Work Order ID 71825

Item Name: Crosstube Aft

DRAWING NO. D407-667-245	TITLE CROSSTUBE ASSY (407 HIGH AFT)	REV. F	DART AEROSPACE LTD ENGINEERING ORDER		D.E.O. NO. D407-667-245-F-1	SHEET NO. SHEET 1 OF 2	SCALE NTS
DRAWN <i>A</i>	CHECKED <i>97</i>	MFG. APPR. <i>E</i>	APPROVED <i>140</i>	DE APPR. <i>#</i>			
DATE 11.04.08	DATE 11.04.12	DATE 11.04.12	DATE 11.04.12	DATE 11-04-12

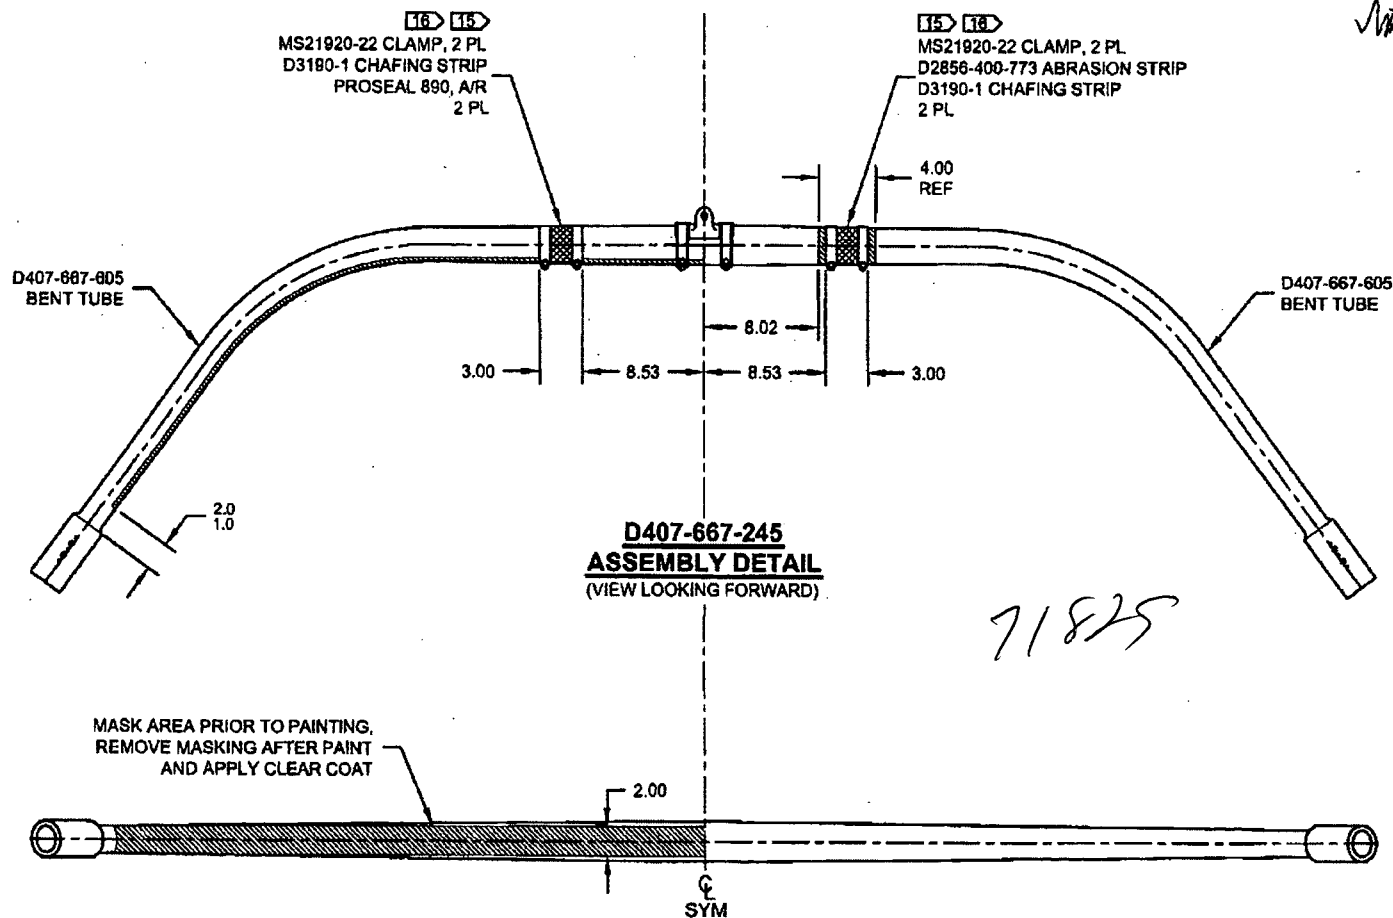
REMOVED ABRASION STRIP IN FAVOR OF A THIN LAYER OF PROSEAL 890.

NOTES 2 AND 15, SHEET 1 ARE AMENDED AS FOLLOWS:

- 2) FINISH: CHEMICAL CONVERSION COAT PER DART QSI 005 4.1
PRIME INSIDE AND OUTSIDE PER DART QSI 005 4.2
MASK UNDERSIDE OF CROSSTUBE AS SHOWN (HATCHED AREA) AND
PAINT OUTSIDE PER DART QSI 005 4.2
REMOVE MASKING AND APPLY CLEAR COAT
- 15) APPLY A THIN COAT OF PROSEAL 890 ON INSIDE CONCAVE SURFACE OF D3190-1
CHAFING SHIELDS AND LET CURE PER MANUFACTURER'S INSTRUCTIONS. INSTALL
PROSEALED D3190-1 CHAFING SHIELDS ONTO CROSSTUBE BY APPLYING A THIN COAT
OF PROSEAL 890 ONTO CROSSTUBE. BE SURE TO ELIMINATE ANY AIR GAPS.
